P 531896

A REPAIR

## ON-SITE SEWAGE DISPOSAL SYSTEM HOWARD COUNTY HEALTH DEPARTMENT BUREAU OF ENVIRONMENTAL HEALTH

ADDRESS: 7538 Cherry Tree Drive PROPERTY OWNER: Anna Smith

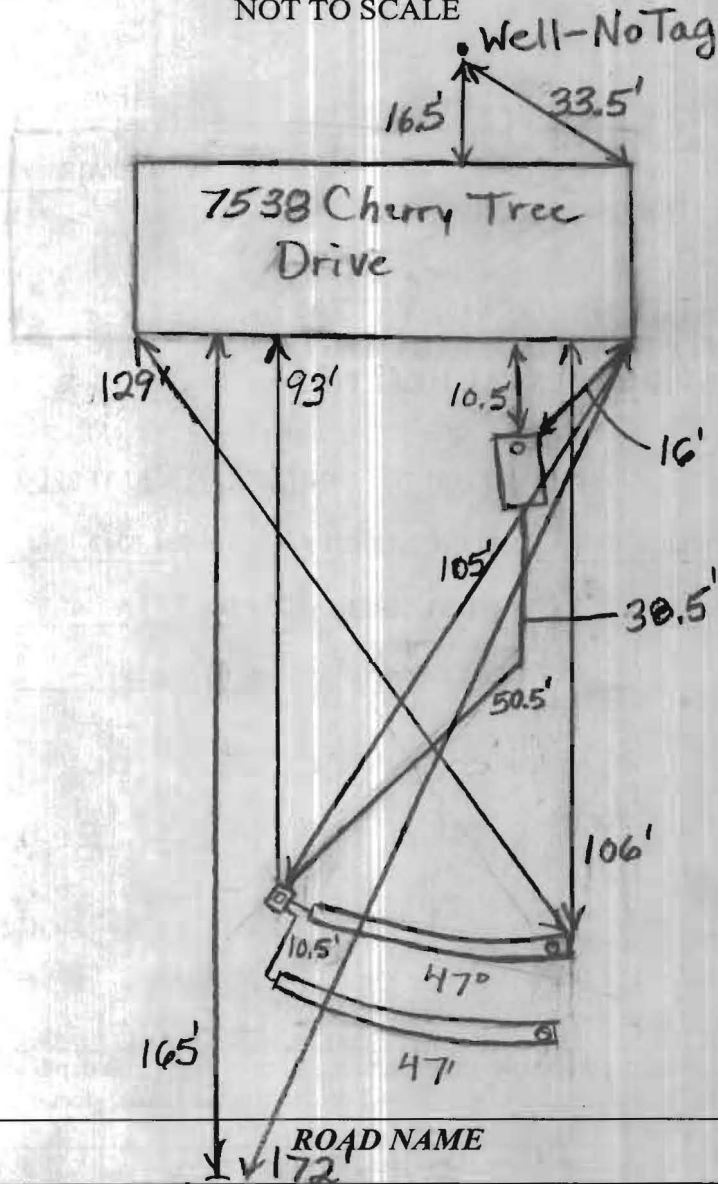
8/24/09 I install 2 trenches on contour above drywell and stay away from swale that is on the opposite side of the backyard as the septic tanks cannot locate buried well that is at 7542 Cherry Tree Drive. Must locate well and keep 100' from trenches before starting. (BB) 9/8/09 A.M. Well located on neighbor's property. Trenches started. Distribution box set. (BB) 9/8/09 P.M. Trenches finished. Drywell pumped out. System O.K. Can cover and finish abandoning drywell. (BB)
